**2<sup>nd</sup> Further Information**

**Proposed Temporary Warehouse (Excluding Dangerous Goods Godown) with Ancillary Facilities  
and Associated Filling of Land and Pond for a Period of 3 Years in "Agriculture" Zone,  
Various Lots in D.D. 107 and Adjoining Government Land, Kam Tin, Yuen Long, N.T.**

**(S.16 Planning Application No. A/YL-KTN/1180)**

**Response to Comment**

Drawing No. W1010/112 Stage P Rev. A

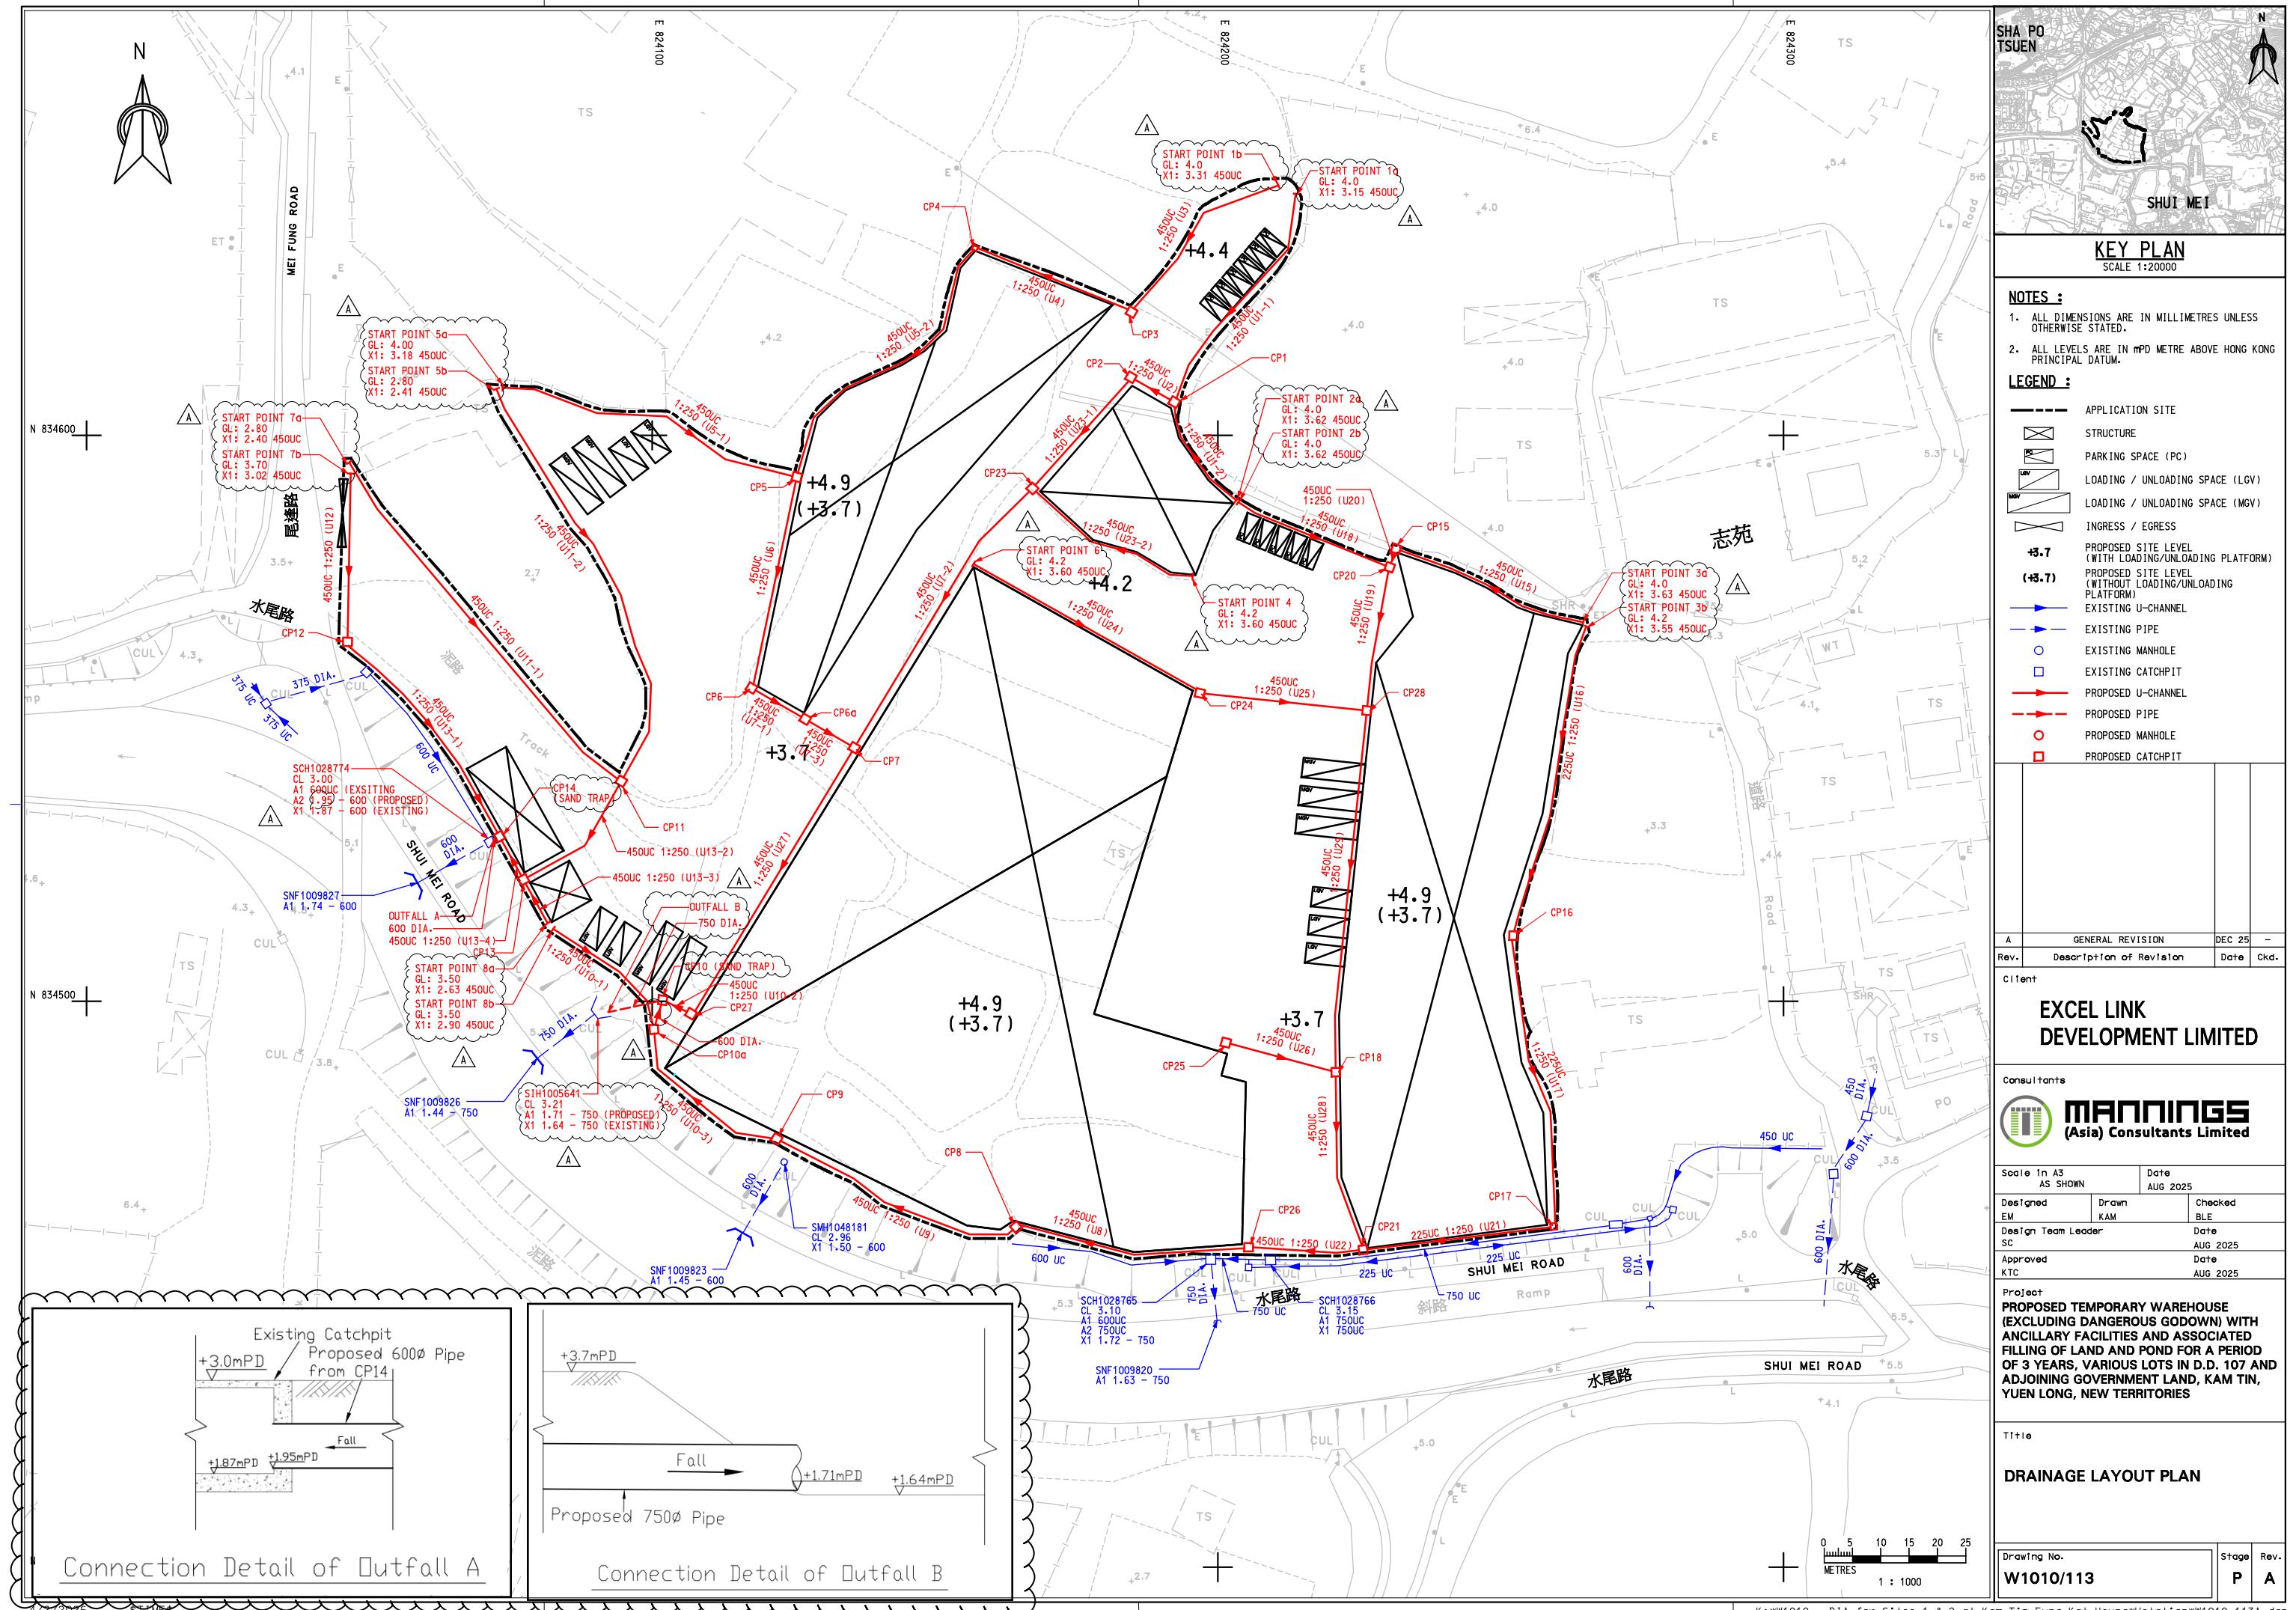
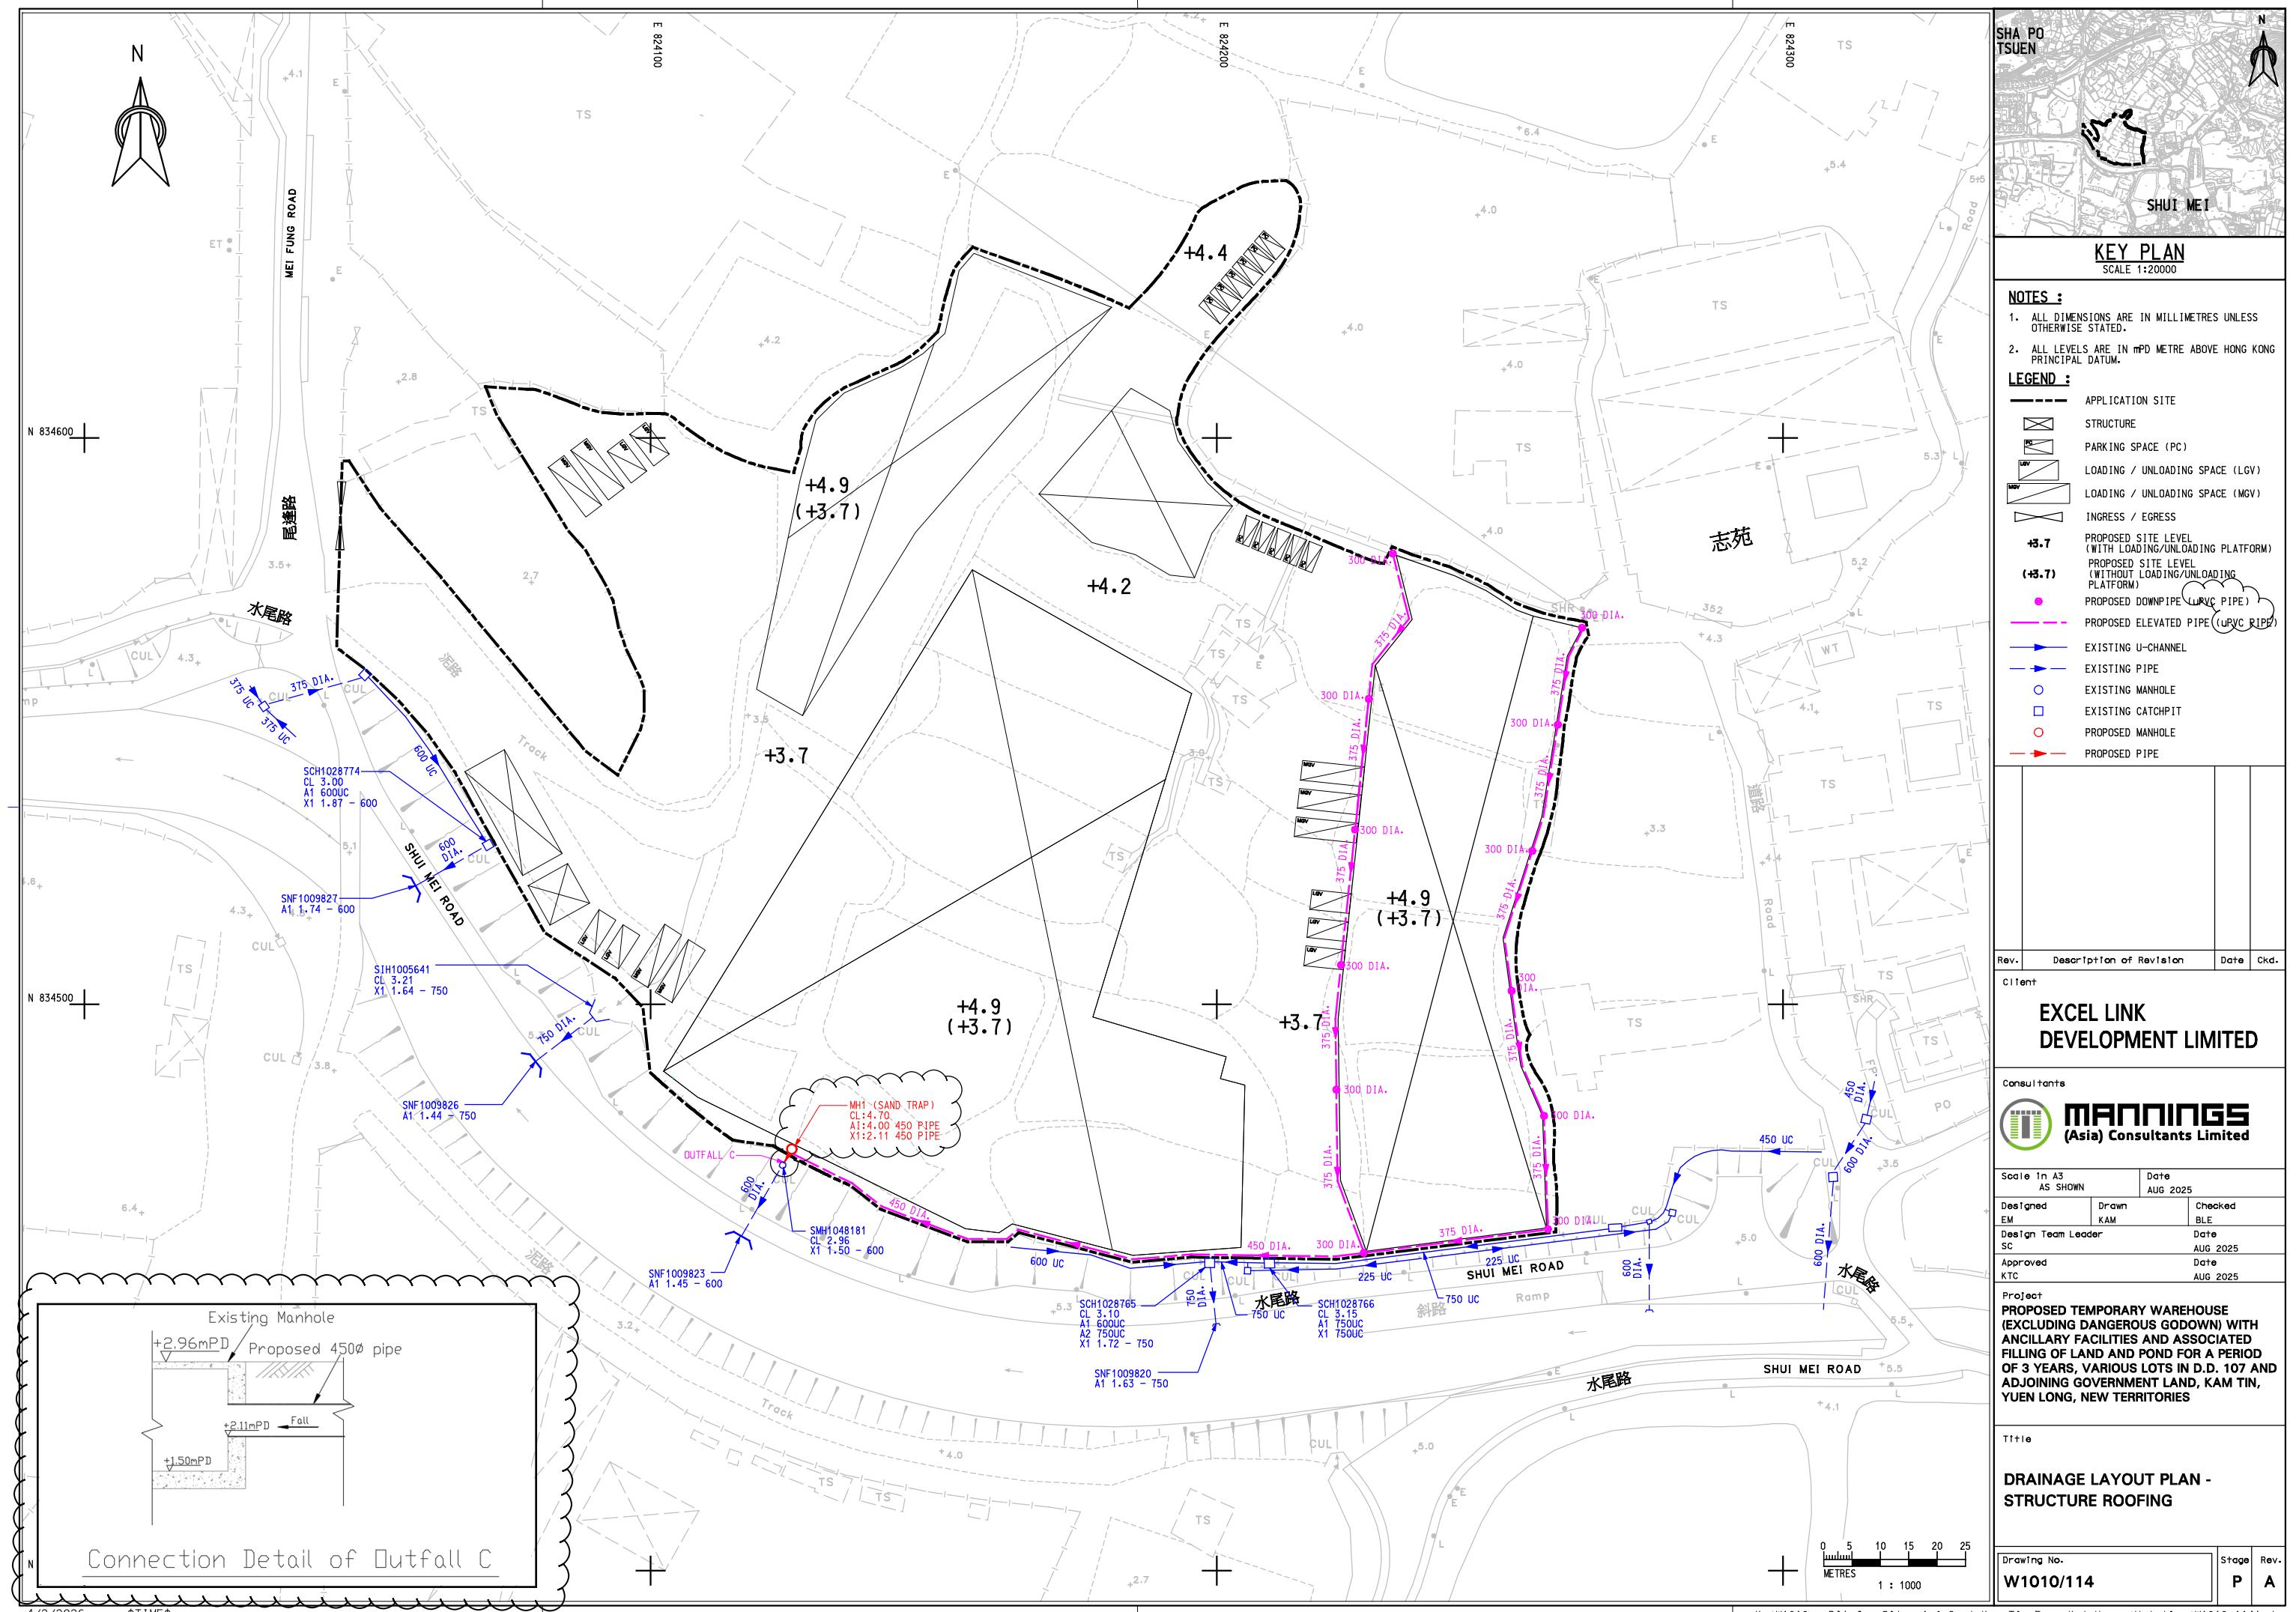
| Departmental Comments   | Applicant's Responses   |
|---|---|
| <p>(2) Cross sections showing the proposed drainage facilities and existing and proposed ground levels of the captioned site with respect to the adjacent areas should be given. Some information is missing in the submitted cross sections. Also, the applicant should clarify discrepancy of the proposed surface channels shown in the submitted drainage plan and Section C.</p> | <p>The cross sections in drawing no. W1010/112 have been revised to show the proposed drainage facilities along with the existing and future ground levels of the captioned site with respect to the adjacent areas.</p> <p>The surface channel presented in Section C has been deleted to be consistent with the proposed drainage plan.</p>   |
